BID ADDENDUM NO. 2

March 20, 2020

Elmira City School District
Fuel Island Replacement
HUNT No.: 2012-223

BUS GARAGE SED #07-06-00-01-5-017-015
STORAGE BUILDING SED #07-06-00-01-2-075-002

AD2-L1
 DATE:
 3/11/2020
 PROJECT NO:
 2012.223

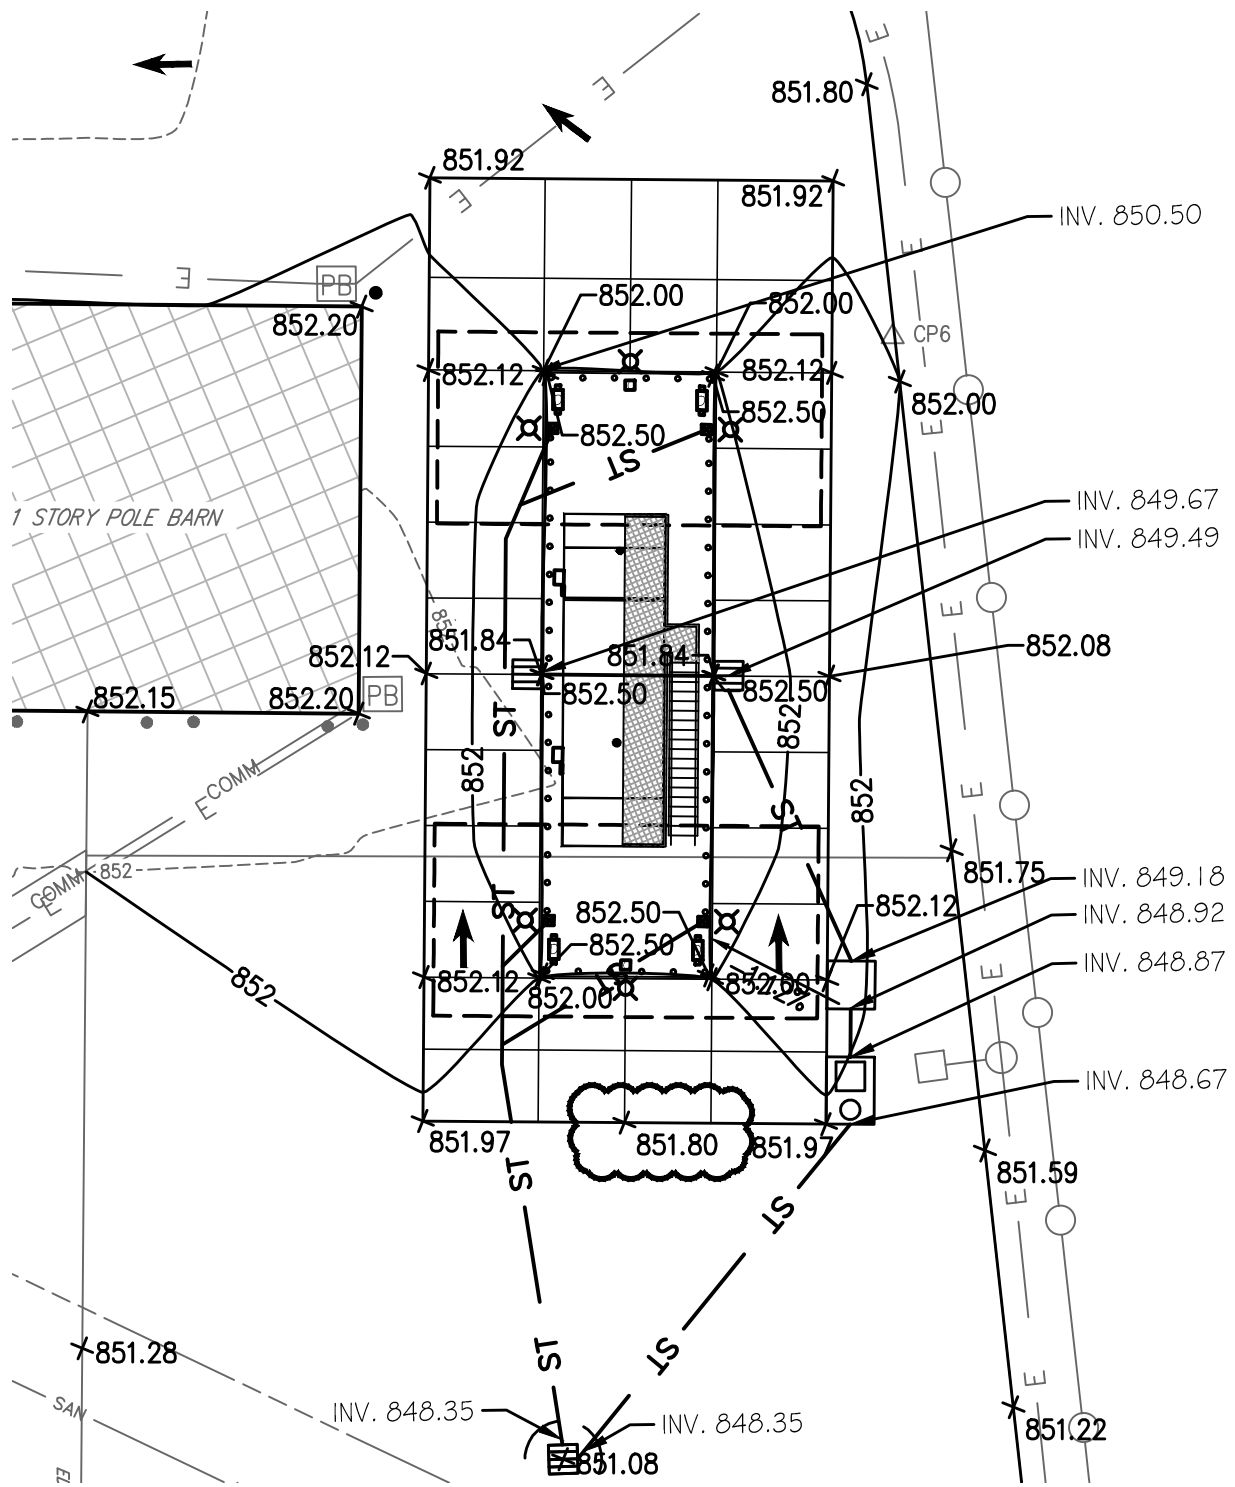
ITEM AD2-5 Refer to Drawing L2.1 – SITE IMPROVEMENT PLAN

ADD Drawing AD2-L1 – SECURITY MANGATE as issued by this addendum.

SPOT ELEVATION FUEL ISLAND REPLACEMENT ELMIRA CITY SCHOOL DISTRICT 1723 CEDAR STREET ELMIRA, NY 14904		HUNT ENGINEERS ARCHITECTS SURVEYORS HORSEHEADS, NY 607 - 358 - 1000 ROCHESTER, NY 585 - 327 - 7949 TOWANDA, PA 570 - 265 - 4868	AD2-L2 DATE: 3/18/2020 PROJECT NO: 2012.223

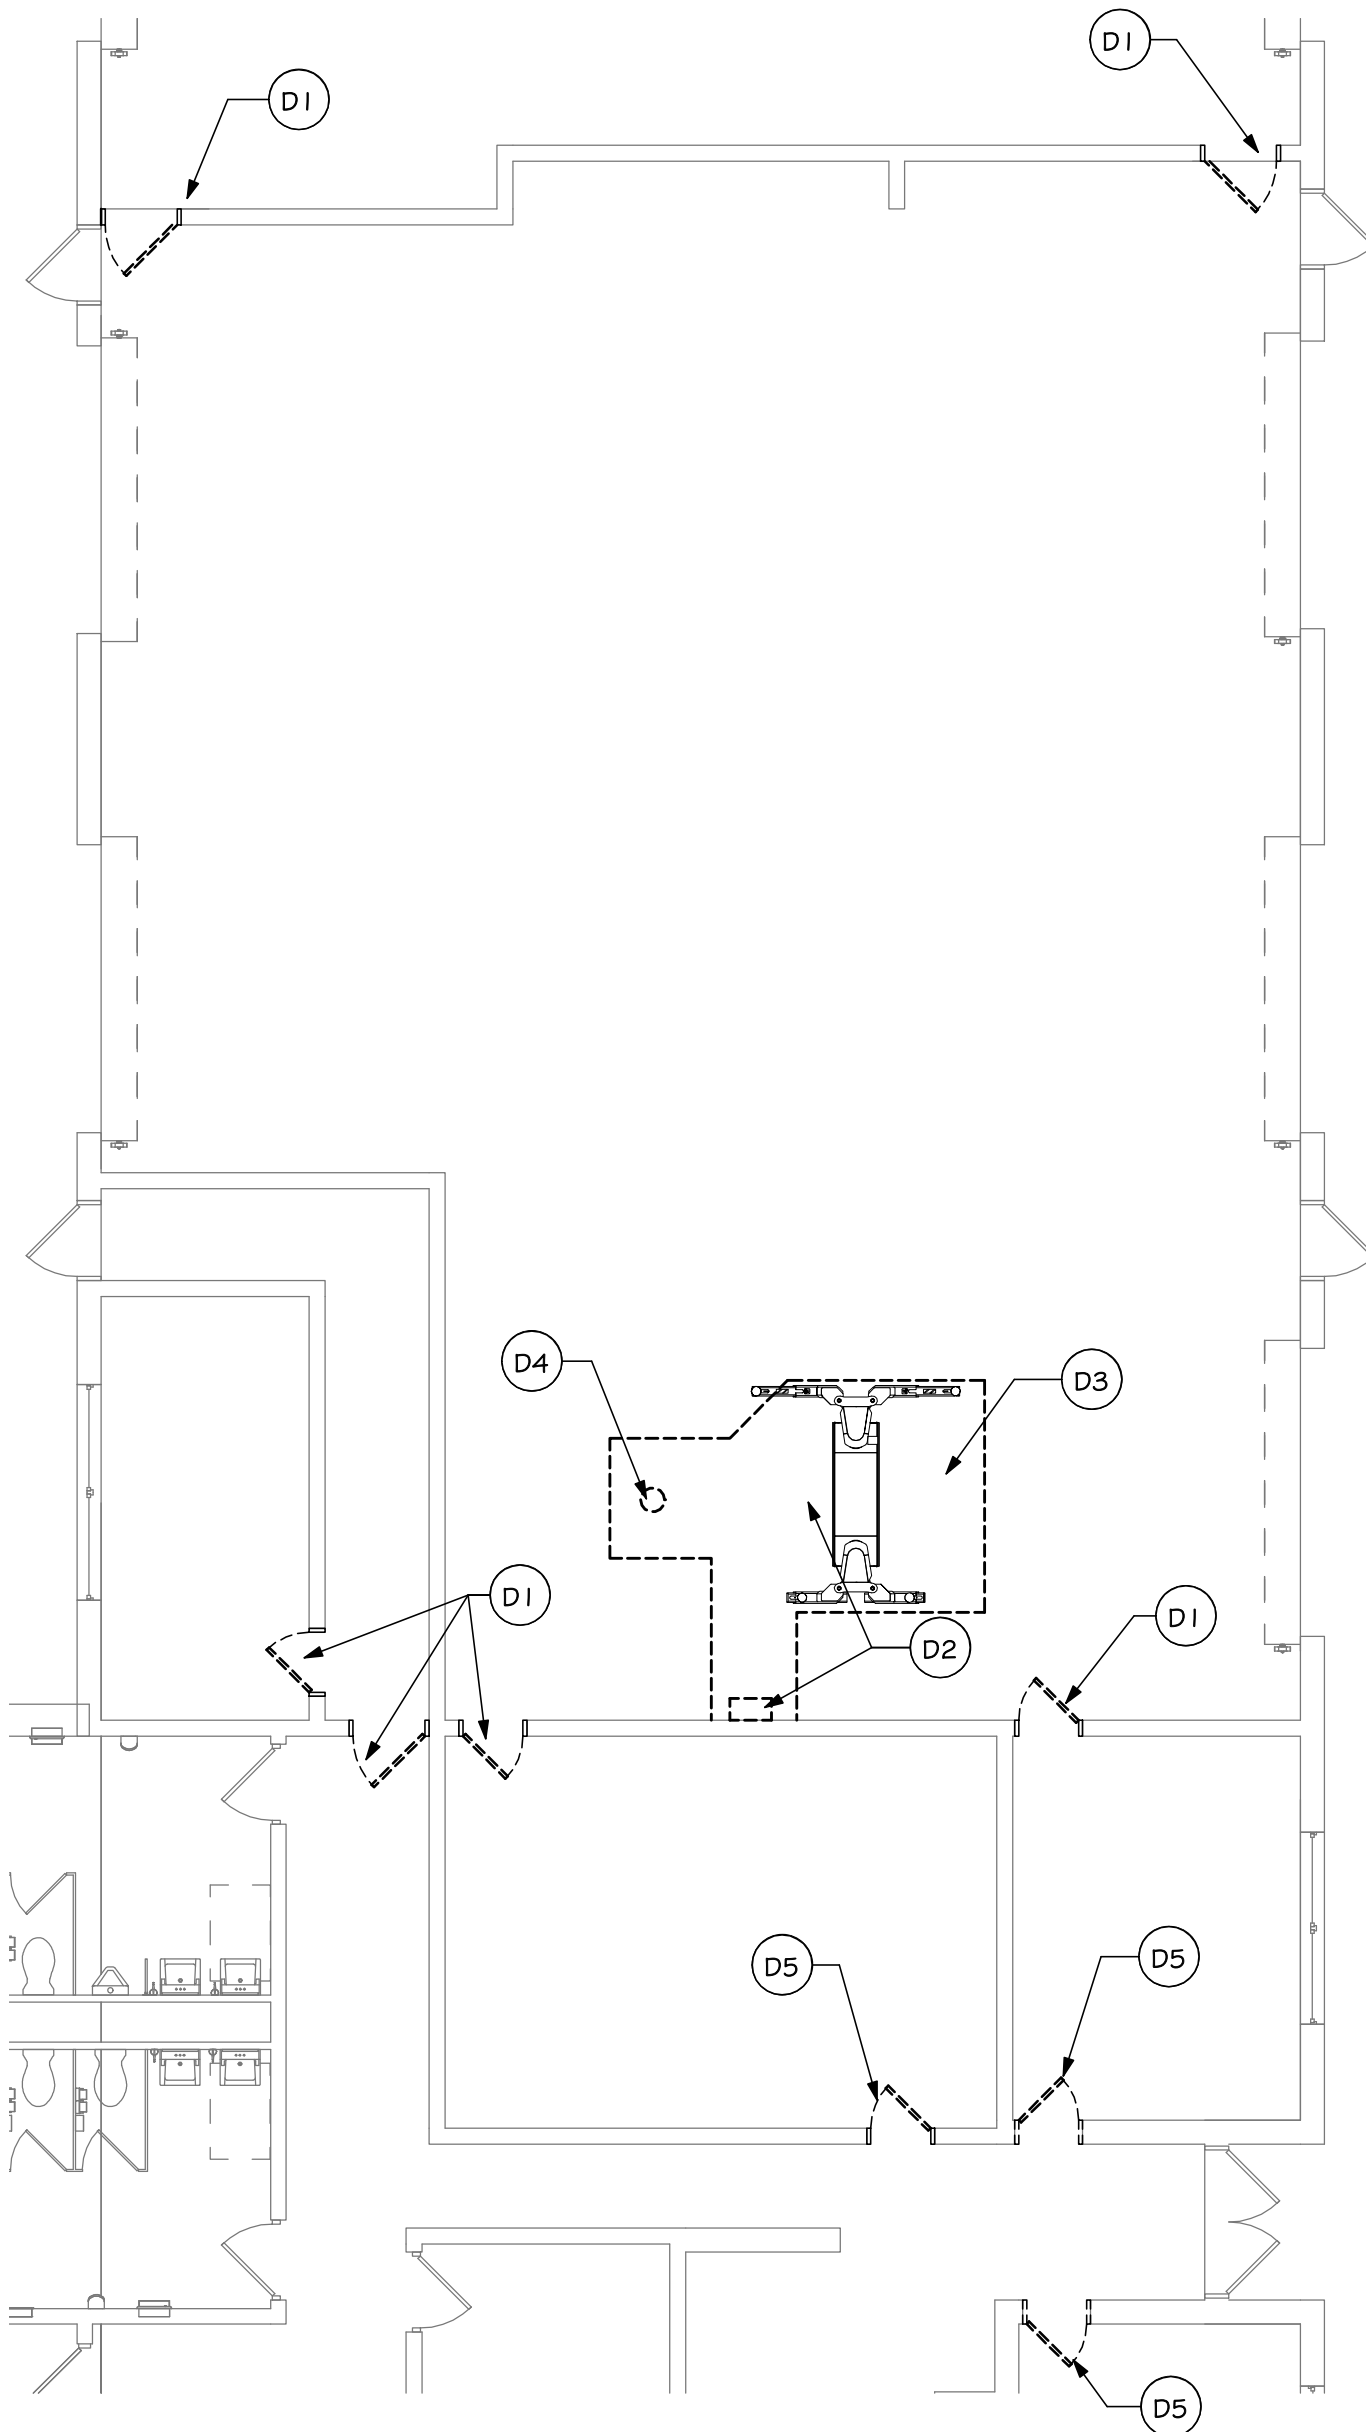
ITEM AD2-7 Refer to Drawing L4.1 – SITE GRADING PLAN

ADD Drawing AD2-L2 – SPOT ELEVATION as issued by this addendum.

AD2-A2

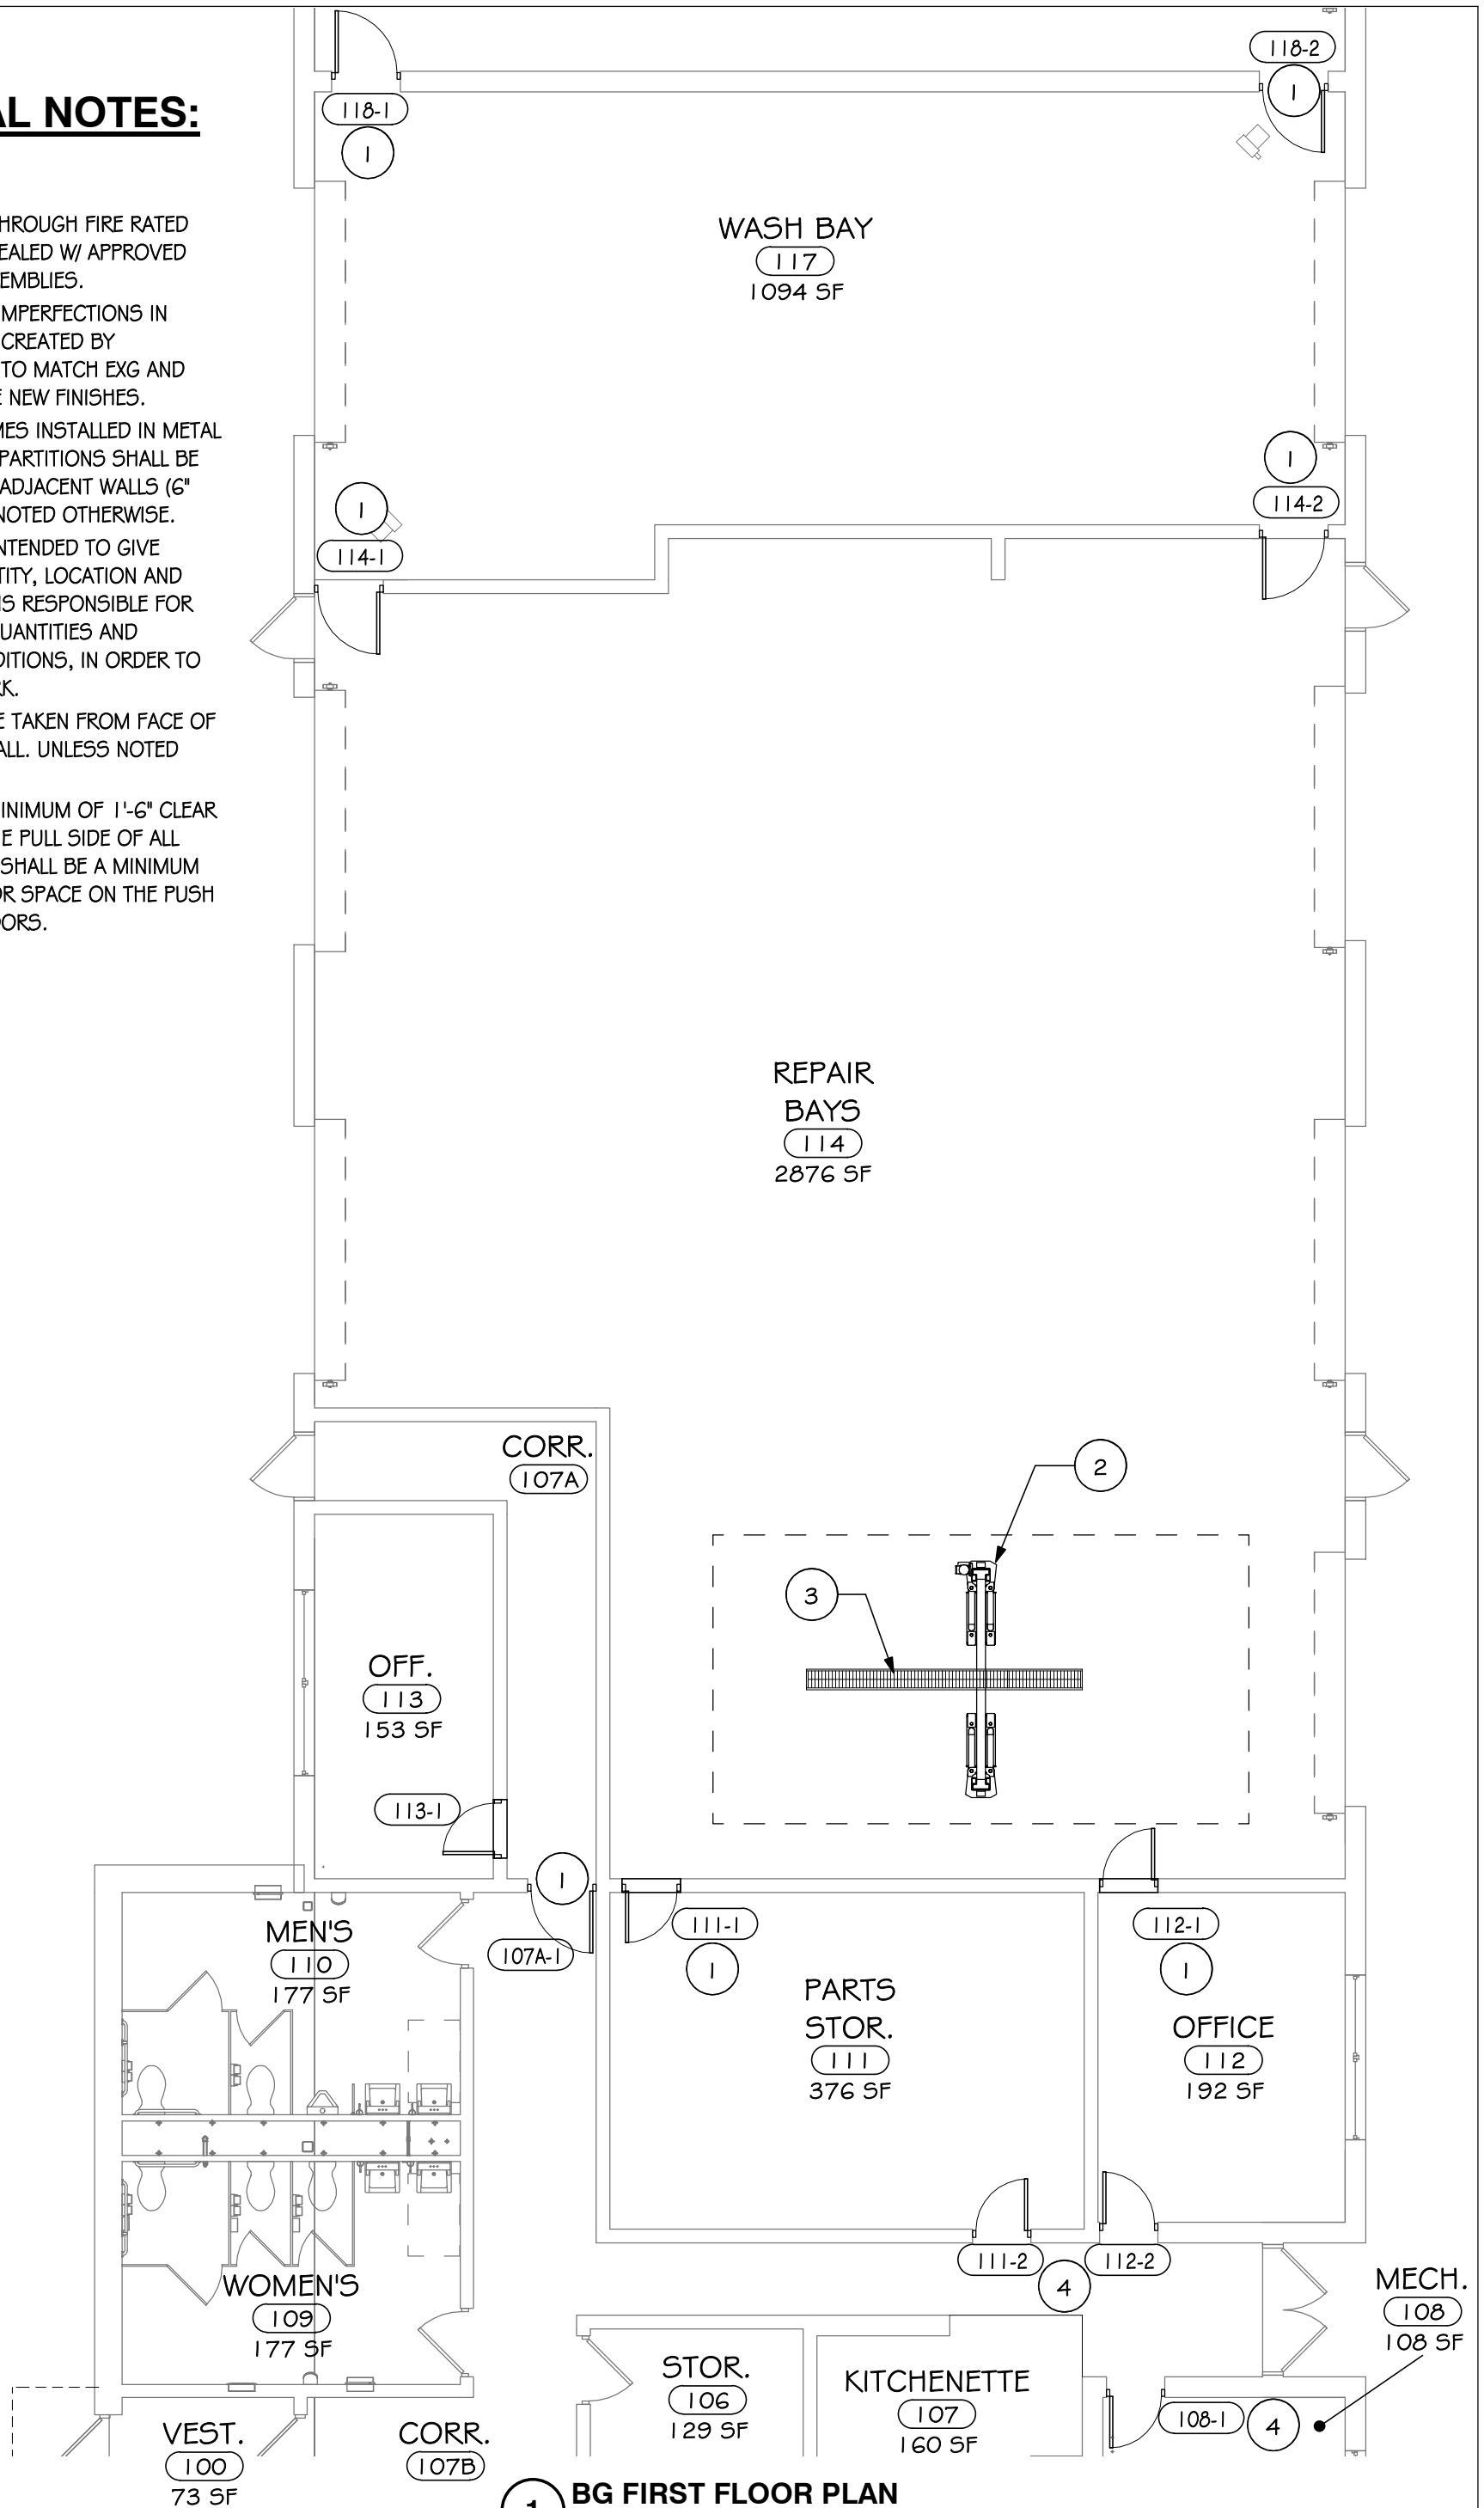
ITEM AD2-9 Refer to Drawing A1.1 – FLOOR PLANS AND DETAILS

AMEND Detail 2 as shown on attached drawing AD2-A2 as issued by this addendum.
